Ian Holyoake – submitter
Late submission to s42A Strikethrough

TSS deposition into water from stormwater infrastructure.
Gross Pollutant Traps

16 April 2025 amended 30 April 2025

Late Submission as granted by panel on 1 April 2025

**Examination of 'treatment train'**

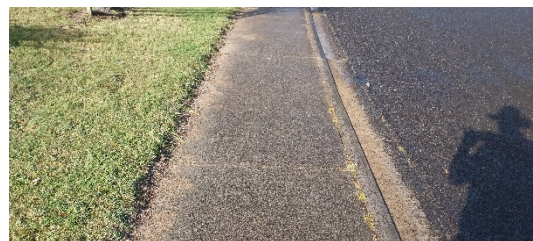
While it is accepted the GPT has captured some sand and organic matter its relevance within the stormwater treatment train in respect to adverse deposition on the environment must be debated.

1. The Whangamata GPT tests are biased and unreliable because:
 - a. The upstream catchpits had not been cleaned. On 8 April 2025 as part of our investigation we checked 6 of the immediate catchpits and found the 4 on Ocean Road to hold deposition material up to the outlet into the pipe system. 2 further up were about 2/3 full. NIWA state that catchpits must never reach 1/3 full otherwise the velocity of water will re-suspend sand and organics and enter pipes. Full catchpits mean TSS would not be captured and would enter the pipe network and enter the GPT. On this basis we cannot determine what percentage of sediment entering the GPT was being captured. It is our contention that if the catchpits were clean TSS would not enter pipes and the purpose of the GPT be questioned.

- b. The road gutters have never been swept. They contained volumes of sand, organics and stones as depicted. Rain water suspends these and drop into catchpits that were full so would enter pipes and get washed into the GPT. Before commissioning of the GPT gutters could have been swept and cleaned. If swept and removed this material could not enter the pipe network.

- c. Footpaths had sand bleed from grassed areas. Upstream roading from the GPT has footpaths with sand bleed that blows into the gutters and then gets washed into the catchpits that are full.

The results of trapped sediment extracted from the GPT are predictable because TCDC has failed to follow consultants advice to perform maintenance, industry requirements to keep stormwater infrastructure in functioning form so they perform to specifications and as a consequence cannot justify GPT are providing any benefit to the environment that would not have occurred had the existing infrastructure been maintained.

2. The Whangamata GPT sediment captured is not a pollutant so not required. Sand is the basic material Whangamata is built on. The fact some sand becomes airborne in high wind, bleeds from the ground and drops off vehicles onto roads is not of itself harmful to the environment whatever way it makes its way back to waterways or the Ocean.
